ATTACHMENT 7

PUBLIC COMMENTS

Re: Ameresco Kelley Canyon RNG LLC Mitigated Negative Declaration

Figure 1: Map depicting Project in relation to boundaries of Stoneman Park subdivision (highlighted in yellow)

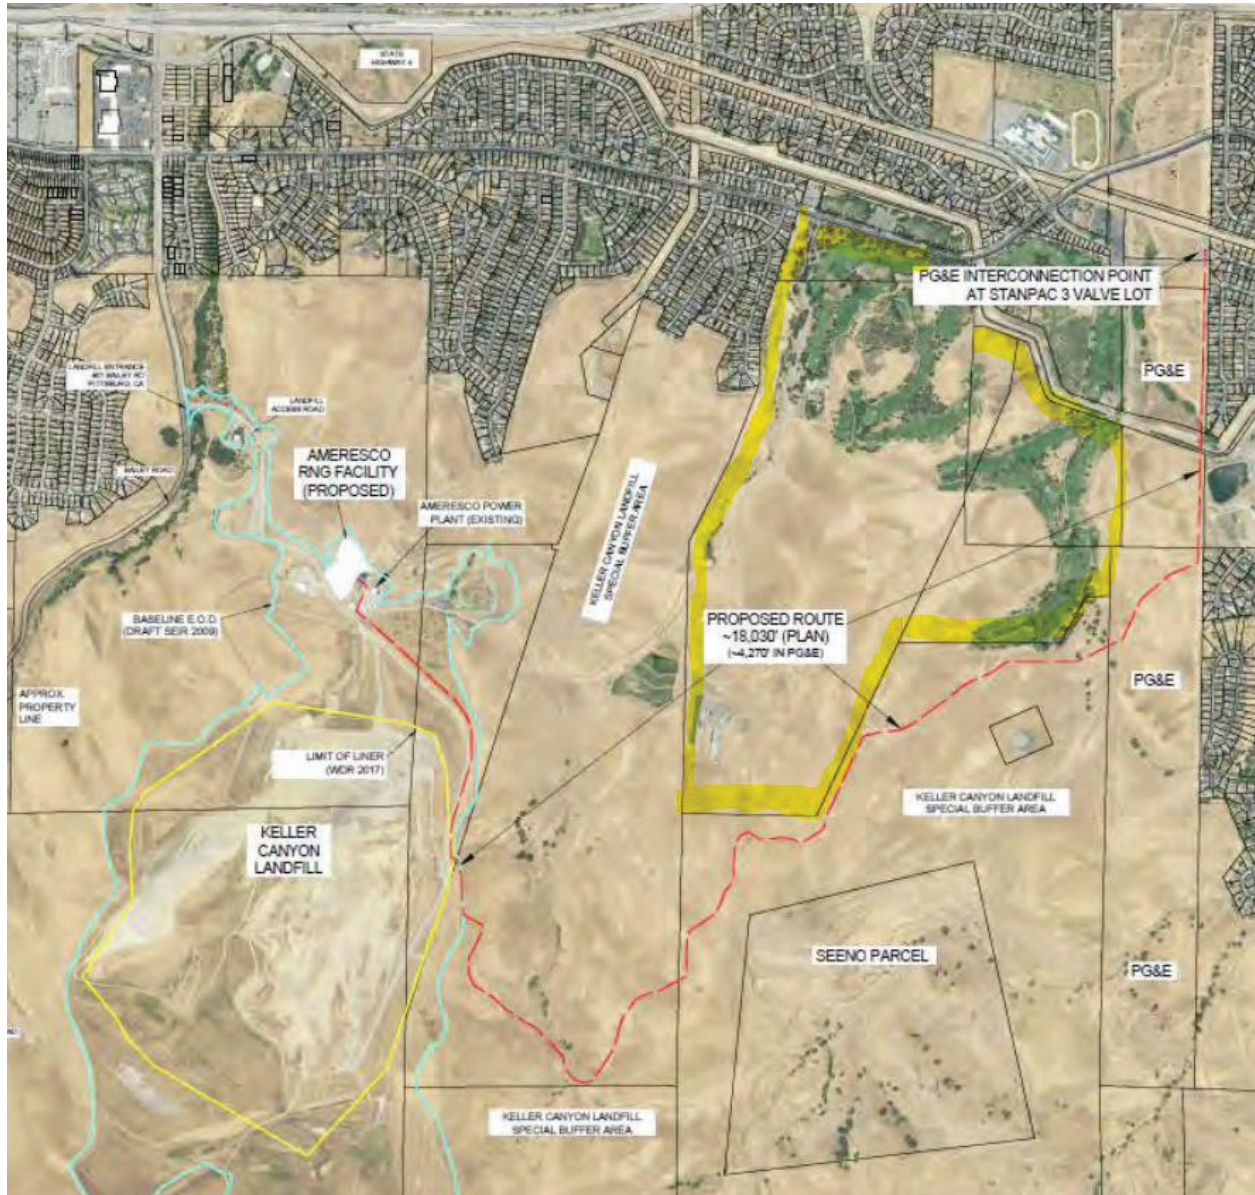
- (3) failure to consider foreseeable future residential developments, such as Stoneman Park.

Given the information gaps present in the MND, it is impossible for our client – or any member of the public – to understand, with any sense of accuracy, the potential risks associated with the proposed Project.
